Office Action Summary

09/347,845

DETAILED ACTION

Fig. 8

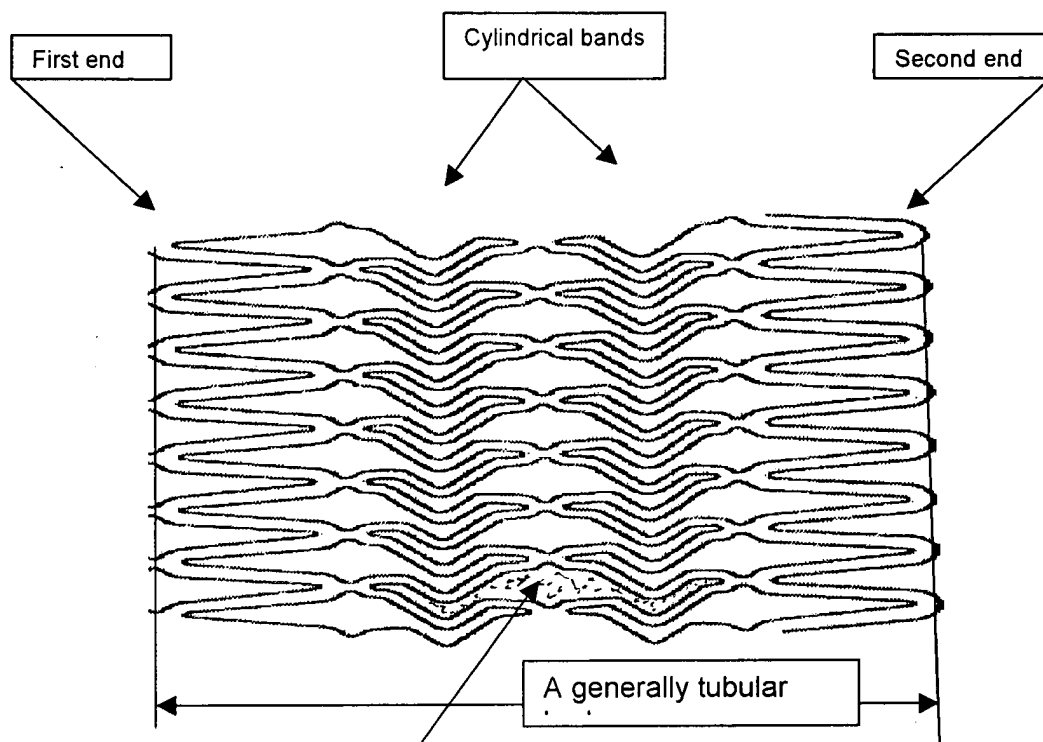
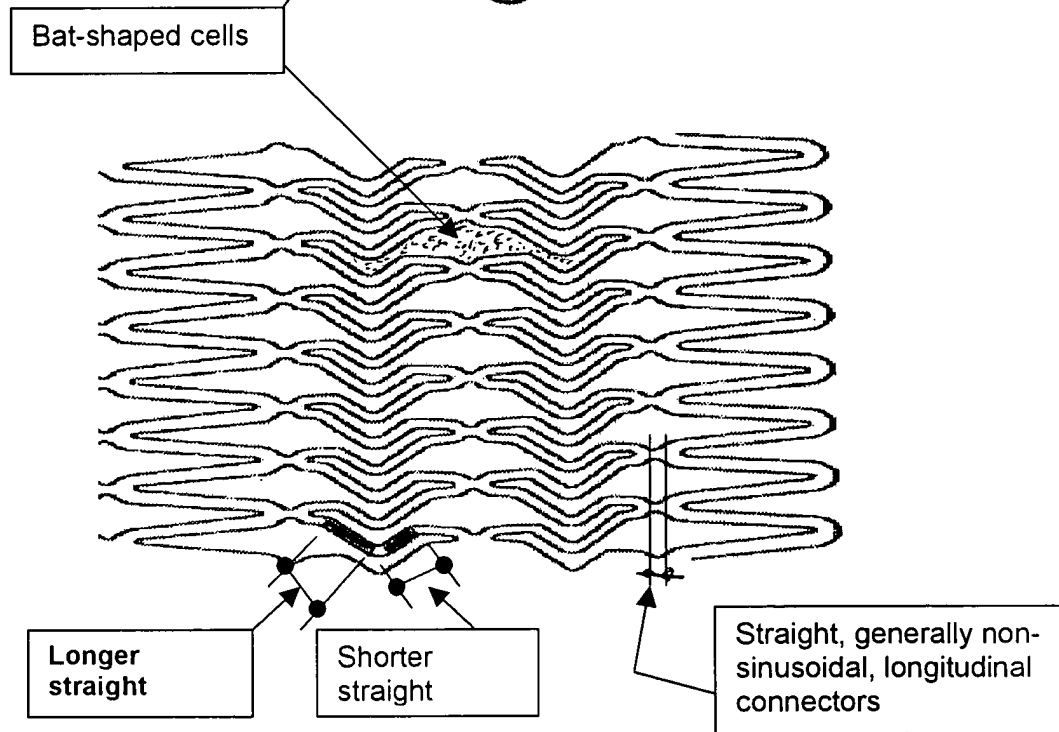
As to claims 1, 3-4, 8-11, and 24-25, VON OEPEN (Fig. 8 and see column 1, lines 36-39, VON OEPEN) includes a **non-sinusoidal zigzag pattern tubular stent (60)** expandable from a contracted condition for easy introduction of the stent into a body lumen (a blood vessel) to an enlarged condition for supporting and keeping the body lumen (the blood vessel) open. Inherently, the stent is biased from a contracted condition either by a balloon or by a self-expanding property of the stent material towards an enlarged condition (as recited in claims 4, 24-25) to support the body lumen. The stent has at least one tubular portion defining a **generally tubular body** with a first band at the first end of said tubular body and a second cylindrical band of said tubular body at the second end of said tubular body, and a central portion between the first and second ends, wherein:

- A plurality of straight and short or long connectors (I-shaped labeled as elements 66, 67) extending substantially parallel to the longitudinal axis of the stent. Notice that in a contracted configuration during deployment of the stent, connectors 66, 67 are squeezed closed one to each other and connectors 66, 67 are substantially parallel to the longitudinal axis of the stent.
- The short longitudinal connectors have a longitudinal dimension substantially smaller than a longitudinal dimension of the diagonal elements (as recited in claim 9). The diagonal elements comprise 1st and 2nd generally straight portions having 1st ends connected to preceding and succeeding diagonal elements and 2nd ends being connected together (as recited in claim 10).
- The diagonal elements of each cylindrical band are out of phase with any adjacent cylindrical band (as recited in claim 11).

As to claims 12-15 and 17-22, VON OEPEN (Fig. 8 as reproduced and shown on page 6 of this paper; see column 1, lines 36-39, VON OEPEN) discloses a tubular stent (60) having at least a tubular portion defining a **generally tubular body** with a first band at the first end of said tubular body and a second cylindrical band of said tubular body at the second end of said tubular body, and a central portion between the first and second ends, wherein:

- A plurality of **straight short and long connectors** (I-shaped) extending substantially parallel to a longitudinal axis (as recited in claims 12 and 15) and **connecting each of the adjacent cells**. Notice that in a contracted configuration during deployment of the stent along a blood vessel, connectors 66, 67 are squeezed closed one to each other and connectors 66, 67 are substantially parallel to the longitudinal axis of the stent.

Notice that a portion of the Von Oepen stent as shown in Fig. 8 defines a generally tubular body as recited in the claims.
